Project	IEEE 802.16 Broadband Wireless Access Working Group < http://ieee802.org/16 >
Title	Define and Use of HO Ranging Code
Date Submitted	2004-06-25
Source(s)	Chulsik Yoon csyoon@etri.re.kr Yong Chang, Changhoi Koo yongchang@samsung.com , chkoo@samsung.com
Re:	Contribution on comments to IEEE P802.16e/D3
Abstract	We newly defined the handover ranging codes for fast handover for MSS and uplink resource savings for unnecessary allocation for transmission of not used large sized TLV fields such as HMAC tuple in the initial stages of network entry/handover.
Purpose	Adoption
Notice	This document has been prepared to assist IEEE 802.16. It is offered as a basis for discussion and is not binding on the contributing individual(s) or organization(s). The material in this document is subject to change in form and content after further study. The contributor(s) reserve(s) the right to add, amend or withdraw material contained herein.

Define and use of HO ranging codes

Figure 1 Handover ranging procedure using the same codes for handover/initial ranging(Not optimized bandwidth allocation, allocating the resources for only initial ranging, by BS.)

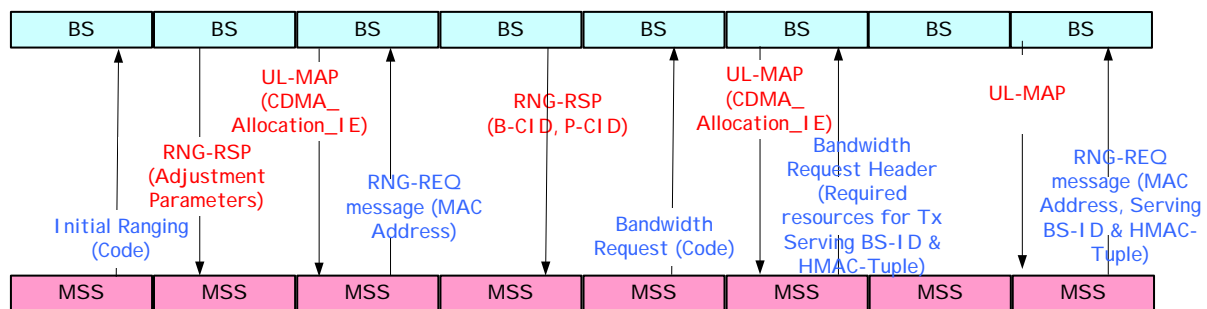
We described the procedure of handover/initial ranging using the same codes for handover/initial ranging in Figure 1. The bandwidth is wasted up and the HO delay is increased because of the additional steps for additional bandwidth requests.

If the BS allocate the additional UL bandwidth for HO ranging [to](#) MSS (not required for the initial network entry MSS), then the precious UL bandwidth is wasted up unnecessarily (for example, approximately entire 2 symbols of 1024 FFT can be wasted up in case of FUSC in OFDMA-PHY.).

Figure 2 Initial Ranging Procedure for OFDMA-PHY

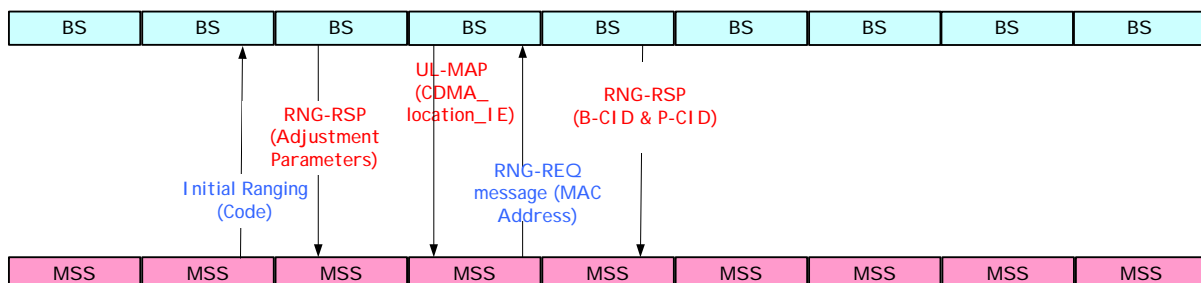
We described the proposed procedures for the initial ranging case in Figure 2 and handover ranging case using the handover ranging codes in Figure 3. As we can see in Figure 3, the handover procedure can be performed in a more swift fashion than that of Figure 1 (current mechanism).
